Peer Review File - Reviewers' comments first round:

This work presents a novel approach to MRI with use of a strategically designed annular dielectric resonator coupled to the MRI system's body coil in order to greatly enhance signal in the region of the body inserted into the resonator, with application here to the human breast. Because conventional MRI typically relies on use of expensive, bulky, application-specific, and system-specific coils with heavy cables connected to the patient table, the potential to replace these coils with a passive resonator with no cables and which could work on MR systems from any supplier could greatly impact workflow, cost, and accessibility of MRI in the future. Presumably, the dielectric resonator would also be less susceptible to failure of electronics than conventional coils, adding to the potential benefits in terms of additional cost reduction and reliability. The authors demonstrate that their novel approach results in significantly lower power requirements (less heating of the patient) and much higher signal-to-noise ratio (higher image quality in the region of the body inserted into the resonator) than the conventional approach.

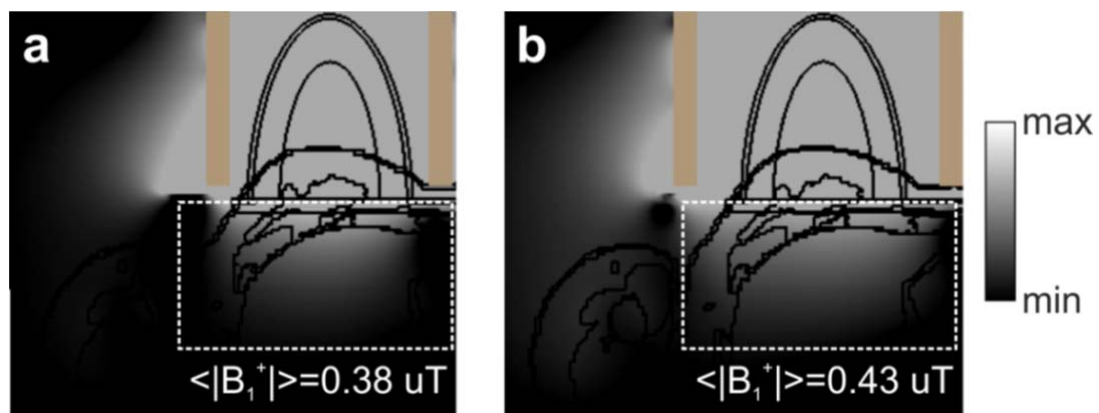
1)As previously mentioned by the reviewers for breast cancer diagnostics it is of high relevance to a) cover the entire breast to the chest wall and b) especially the lateral parts of the FGT (in an optimal case up to the axillary region in order to assure not missing suspicious lesion there). From a practical point of view with your technique it would thus currently be necessary to re-examine the women with a “standard” coil to obtain the rest of images covering all areas of interest which would probably interfere with the aim of saving time (re-placing the patient for the examination is quite time consuming and re-placing a patient causes issues with regards to image co-localization especially for breast imaging), so how realistic is it to cover these lateral, dorsal and medial aspects in future work?

a. Herein you mention to the reviewer that your current design covers the chest wall, and while I agree that your images demonstrate, that some peaks of the image reach the chest wall it is very obvious that the breast coverage to the medial, dorsal and lateral aspects is insufficient for a comprehensive assessment (you can see that substantial amounts of FGT are not depicted as compared to the breast coil), this limitation might benefit from being slightly more emphasized in the discussion for the clinicians reading the manuscript.

2) Your setup (Suppl. Fig 1) seems to be already pushed to the edge of the chest wall quite strictly, so how could it be possible to increase imaged volume towards the chest wall further from a practical point of view (to what degree do you need to maintain the perfect cylindrical shape of the resonator for imaging)?

This is a very important point. All concerns mentioned above can be definitely solved in future work, adapting the current resonator design for real practice, while using the novel targeted approach proposed in our work. In particular, to obtain full coverage of FGT, the following modifications can be done:

1) the usage of ceramic rings with a larger inner diameter, e.g., 20% larger in comparison with the current design, to improve spatial coverage of the resonator. In order to confirm this idea, we performed an additional numerical simulation with this design, which demonstrates a 1.6-fold larger field-of-view and a 1.13-fold higher RF magnetic field in the lateral areas (see Fig. S1a,b below). However, it is worth noting that in this case, a 30% loss in the RF magnetic field enhancement in the breast area is possible. However, compared to the body coil alone the resonator with the larger diameter still enhances the RF magnetic field by 10-folds. So, via

engineering optimization of the design, one should compromise between the effectiveness of the resonator operation and field-of-view.

“To improve the spatial coverage of the resonator, the design with a bigger inner diameter of ceramic disks (126 mm) was simulated. The results demonstrate a 1.6-fold higher field-of-view and a 1.13-fold higher RF magnetic field in the lateral areas (see Supplementary Fig. 4) in comparison with the proposed resonator with an inner diameter of 101.5 mm. However, it is worth noting that, in this case, a 30% loss in the RF magnetic field enhancement (mean value of the B_1^+ -field) in the breast area was observed, i.e., the efficiency of the resonator operation is slightly decreased but still 10-fold higher than compared to the birdcage body coil alone. Thus, it is worth noting that via engineering optimization of the design, one should compromise between the effectiveness of the resonator operation and field-of-view”.

As was mentioned above (please, see the answer to the comment #1), to increase the imaged volume, it is possible to increase the inner diameter of the resonator. Theoretically, there are other options for the resonator design, including spatially curved shapes, which would better fit the patient's anatomy. The general restriction to the design process is that the RF magnetic field created by displacement currents in ceramic parts and better performance can be achieved only when they surround the region of interest. From that point of view, cylindrical shape is an ideal symmetric structure for investigation. Thus, a cylindrical design is a starting point of the non-trivial optimization problem, which will be solved in our future work.

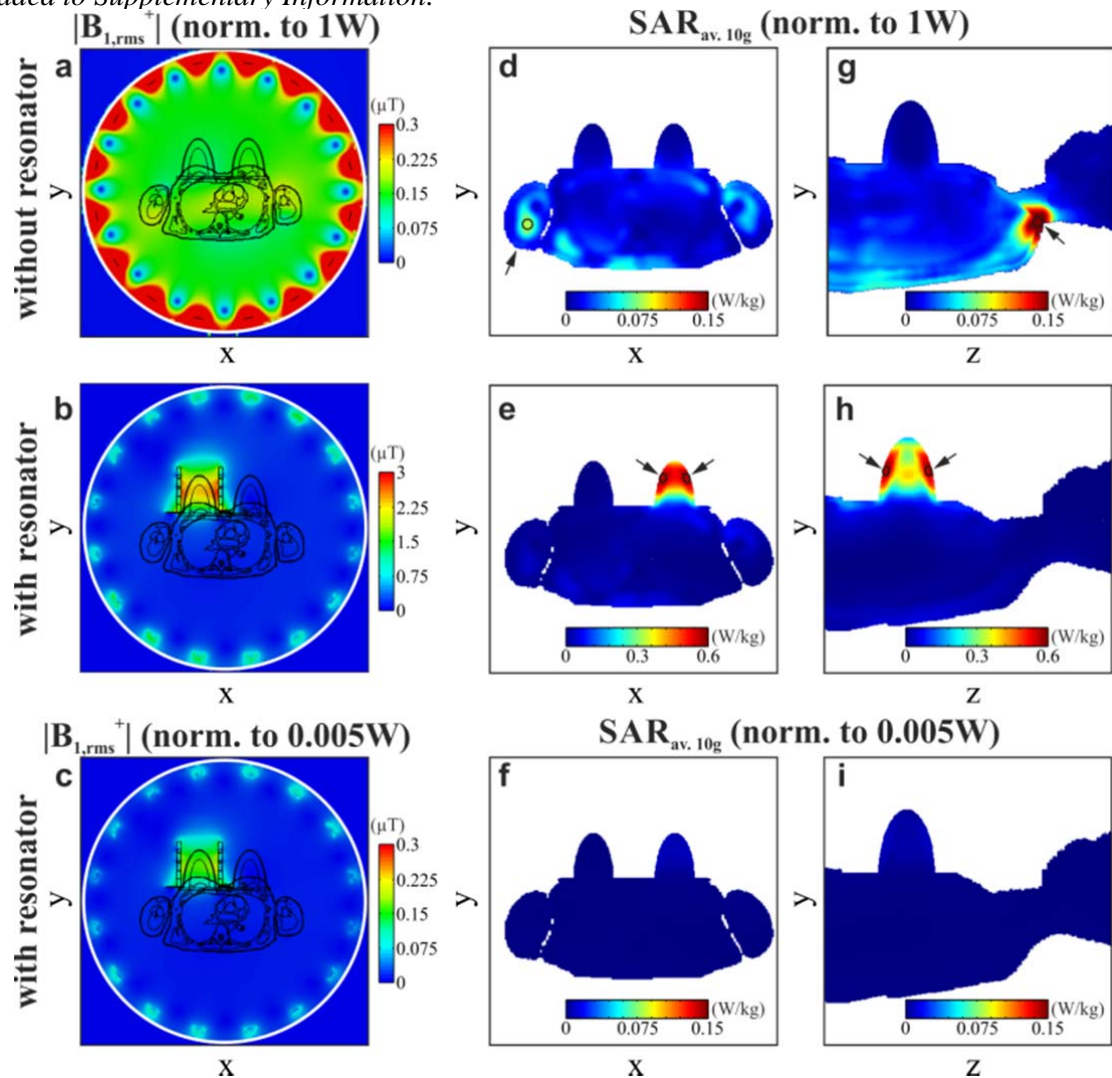
6) Safety of the MRI examination is of utmost importance, so are there any potential emerging safety issues with such a technique that we as medical doctors should anticipate, e.g. with tattoos or breast implants? From your supplemental Figure 2 it seems your SAR peak is almost 10 fold higher (scales are different in between the images, this should be corrected) with a spatial focus on the skin, to what degree does that influence to applicability of the method?

Concerning the tattoos and breast implants, no additional safety issues are expected besides the conventional ones. However, an essential benefit of the proposed resonator is the control of the spatial location of the peak SAR values. The highest SAR values are located within the region of interest with the proposed method, while with the birdcage body coil; their location is much less predictable.

“That means to obtain the same B_1^+ -field value in the breast area, and one should reduce the input power, thus reducing the peak values of SAR (see Supplementary Fig. 2f,i)”.
